Addendum No. 1

RE: Contract # C204878

Buncombe County (I-2513AA, I-2513AB)

I-40 FROM EAST OF SR-1224 TO PAVEMENT JOINT WEST OF SR-3412,
AND I-26, I-40 AT I-40/US 19/23 INTERCHANGES IMPROVEMENTS

PROJECT REFERENCE NO. I-2513 AA/AB	SHEET NO. UC-8
DESIGNED BY: JKC	
DRAWN BY: JKC	
CHECKED BY: CLS	
APPROVED BY: CDB	
REVISED:	
NORTH CAROLINA DEPARTMENT OF TRANSPORTATION	
UTILITIES ENGINEERING SECTION PHONE: (919) 707-6690 FAX: (919) 250-4151	
UTILITY CONSTRUCTION PLANS ONLY

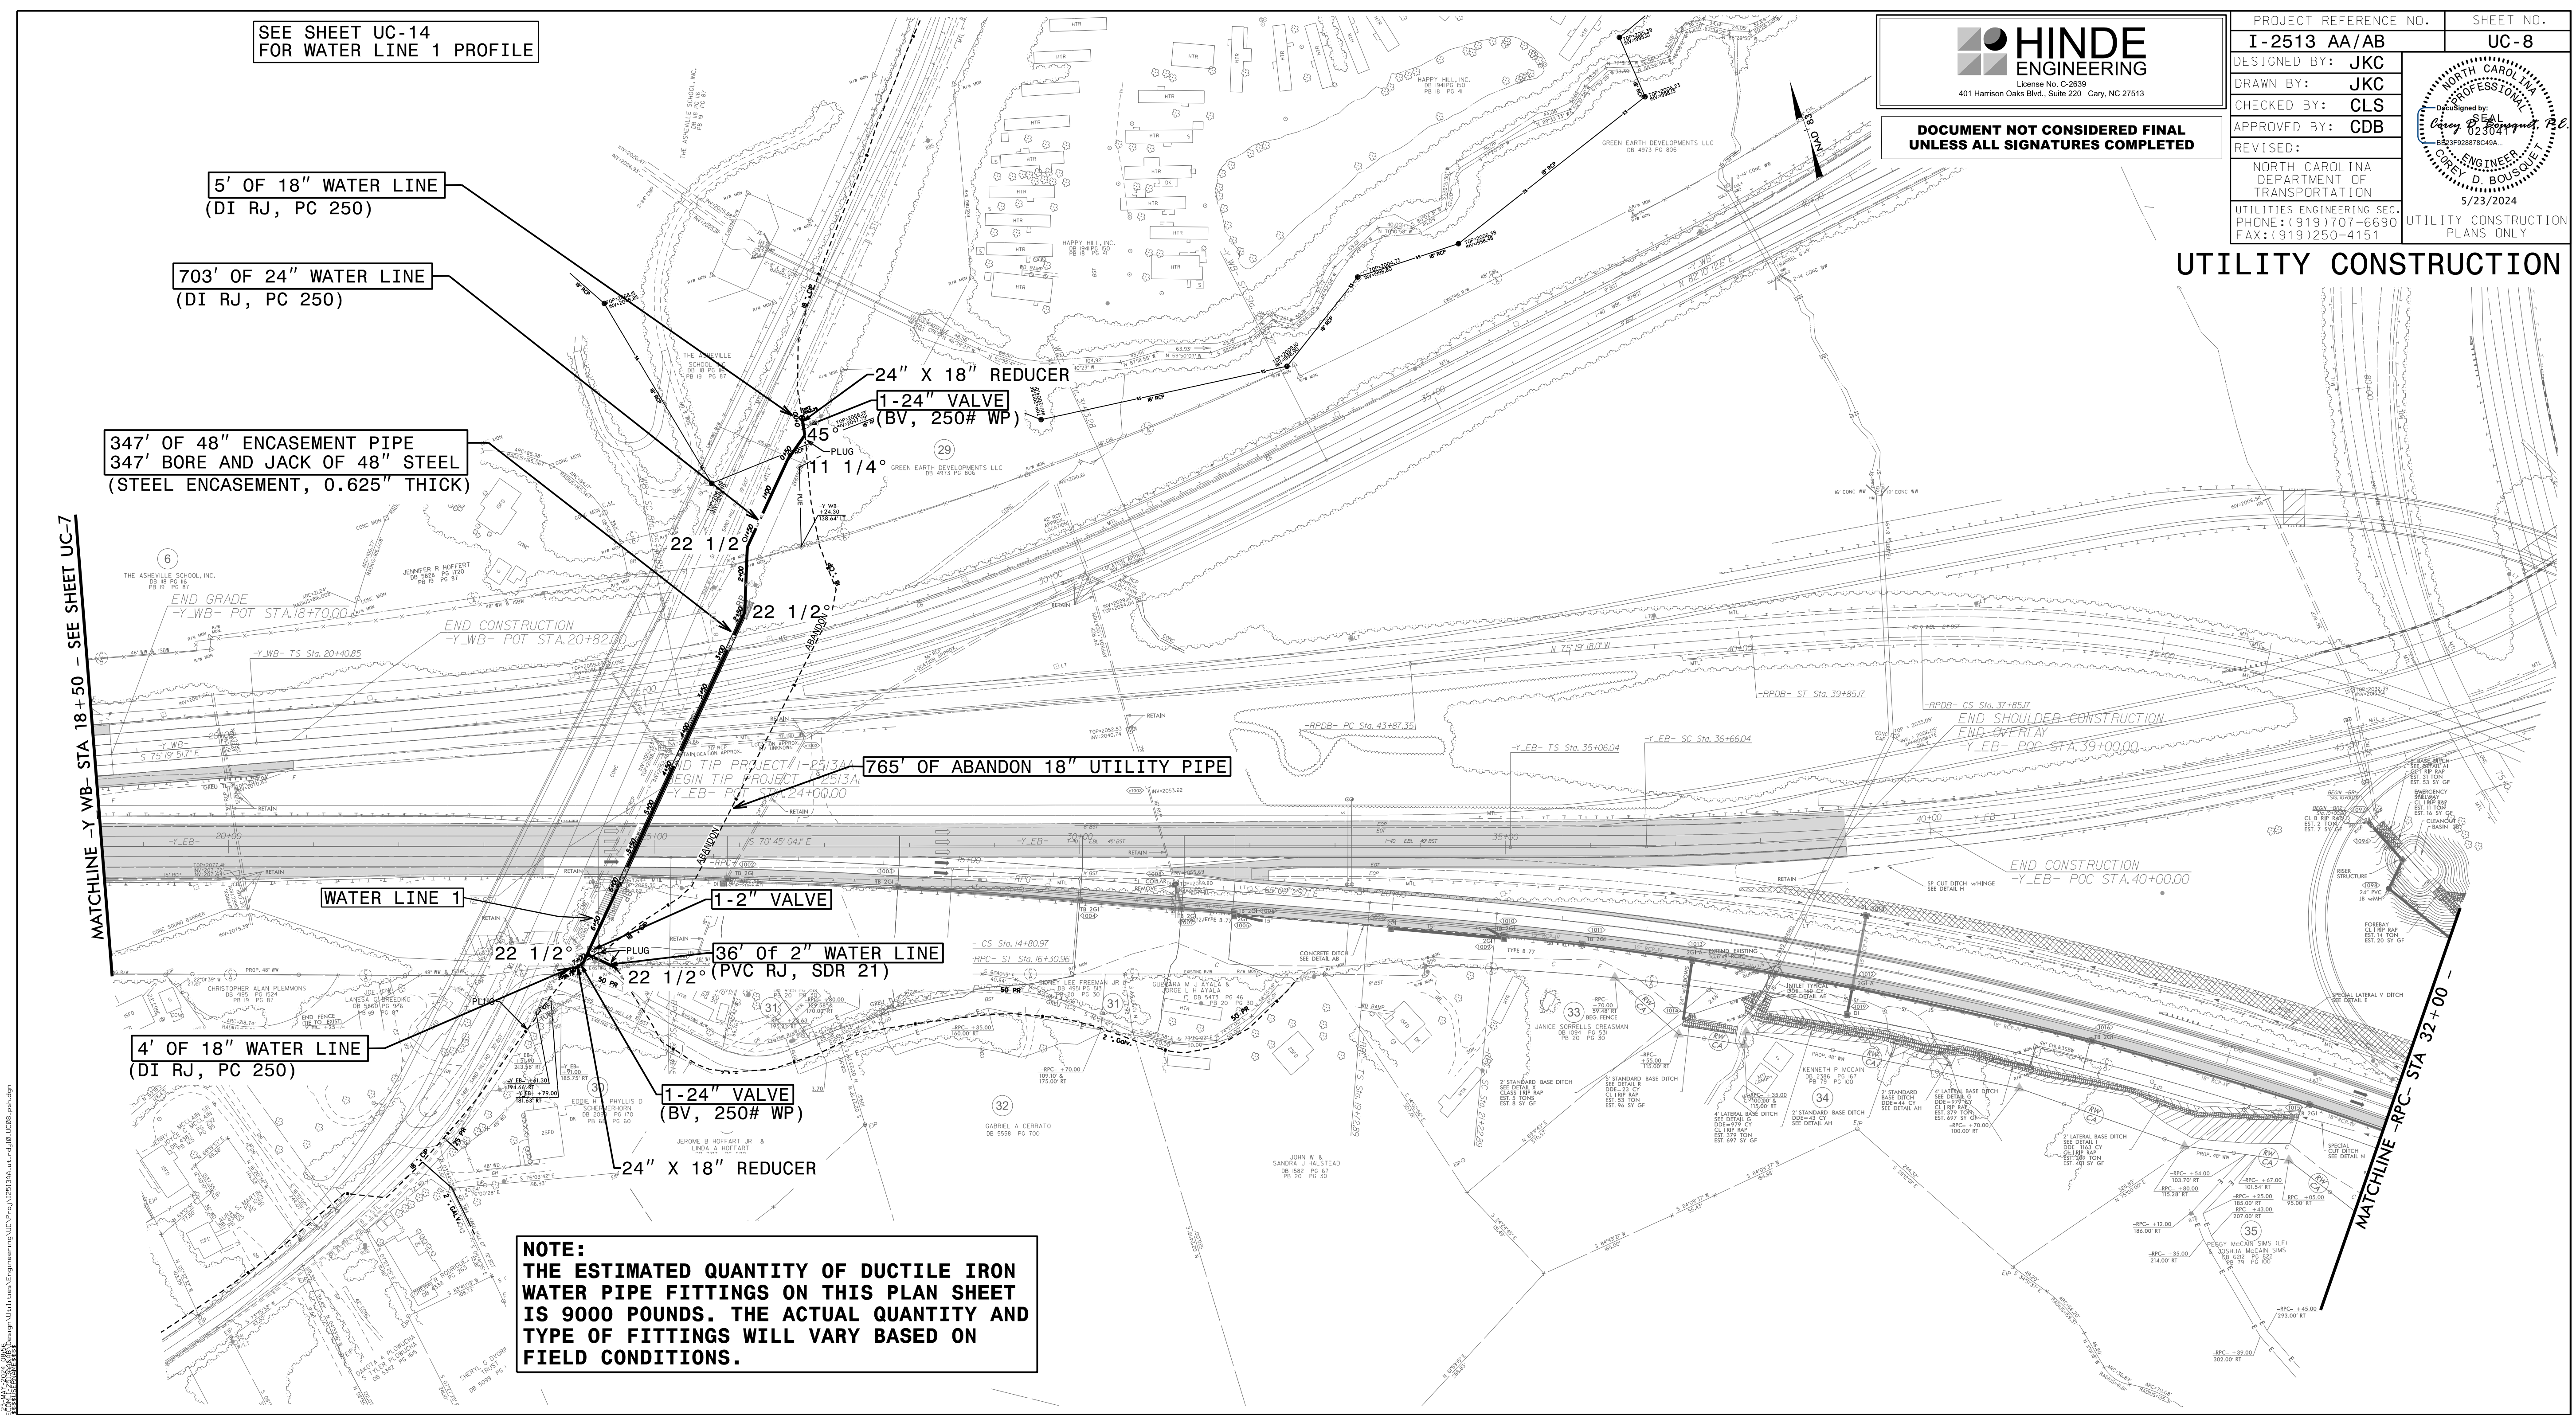
Sheet No.	Revision
UC-08, UC-14	48" steel encasement thickness revised from 0.500" to 0.625".

347' OF 48" ENCASEMENT PIPE
347' BORE AND JACK OF 48" STEEL
(STEEL ENCASEMENT, 0.625" THICK)
